Access Compliance Report Public Rights-of-Way (Curb Ramps)

Main Street: FAIRHAVEN_AVE Cross Street: ESPLANADE_ST Location: NW

ADA ID: RPAT211111105811 Ramp Type: Type 4 - Parallel Initial Pass/Fail: Fail Overall Compliance: No Severity Score: 16

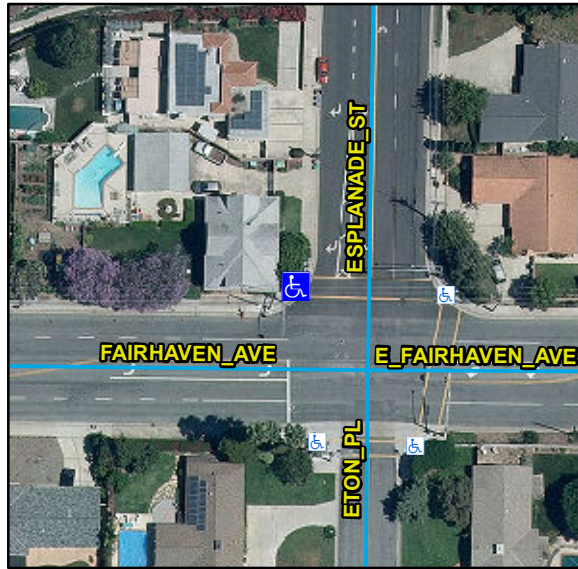
R304.5.3, R304.3.2, STD 1115

Remove & Replace Curb Ramp With Two New Directional Ramps or Equivalent.
